## **7.7 Control Systems Not Required for Safety**

The information in this section of the reference ABWR DCD, including all subsections and figures, as modified by the STP Nuclear Operating Company Application to Amend the Design Certification rule for the U.S. Advanced Boiling Water Reactor (ABWR), "ABWR STP Aircraft Impact Assessment (AIA) Amendment Revision 3," dated September 23, 2010 is incorporated by reference with the following departures and supplements.

Figure 7.7-11 Simplified Functional Diagram of the Automatic Power Regulation System

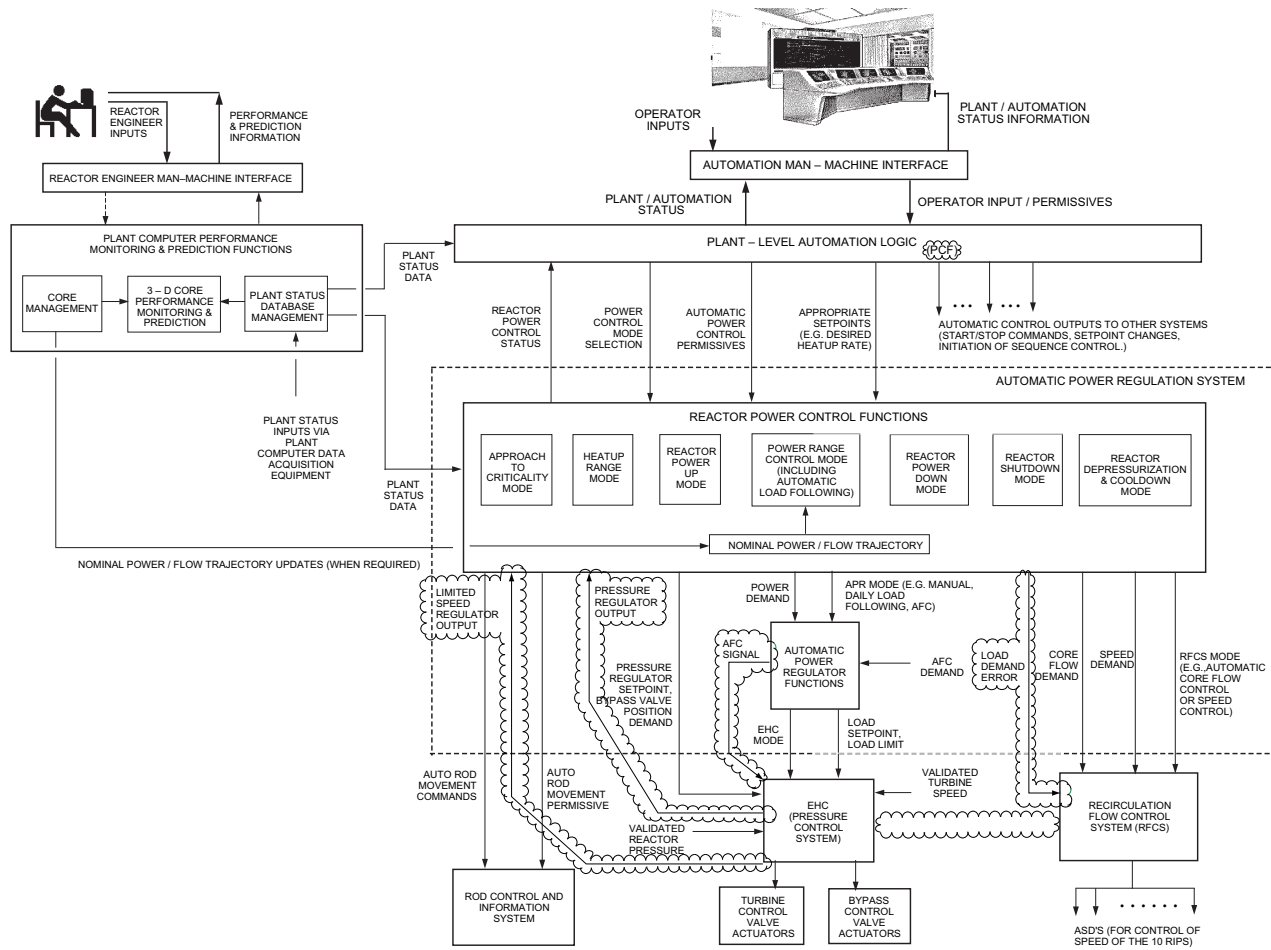
STD DEP 7.7-20 (Figures 7.7-5, 7.7-7, 7.7-11)

STD DEP 7.7-24 (Figures 7.7-11, 7.7-12, 7.7-13)

The primary objective of the Automatic Power Regulator (APR) System is to control reactor power during reactor startup, power generation, and reactor shutdown, by appropriate commands to change rod positions, or to change reactor recirculation flow. The secondary objective of the APR System is to control the pressure regulator setpoint (or turbine bypass valve position) during reactor heatup and depressurization (e.g., to control the reactor cooldown rate). The APR System consists of redundant process controllers. Automatic power regulation is achieved by appropriate control algorithms for different phases of the reactor operation which include approach to criticality, heatup, reactor power increase, automatic load following, reactor power decrease, and reactor depressurization and cooldown. The APR System receives input from the ~~plant computer~~ PCE, the Power Generation Control System (Subsection 7.7.1.5.42), the Steam Bypass and Pressure Control System (Subsection 7.7.1.8), and the operator's control console. The output demand signals from the APR System are to the RCIS to position the control rods, to the RFC System to change reactor coolant recirculation flow, and to the SB&PC System for automatic load following operations. The ~~PGSPGCS~~ performs the overall plant startup, power operation, and shutdown functions. The APR System performs only those functions associated with reactor power changes and with pressure regulator setpoint (or turbine bypass valve position) changes during reactor heatup or depressurization. A simplified functional block diagram of the APR System is provided in Figure 7.7-11.
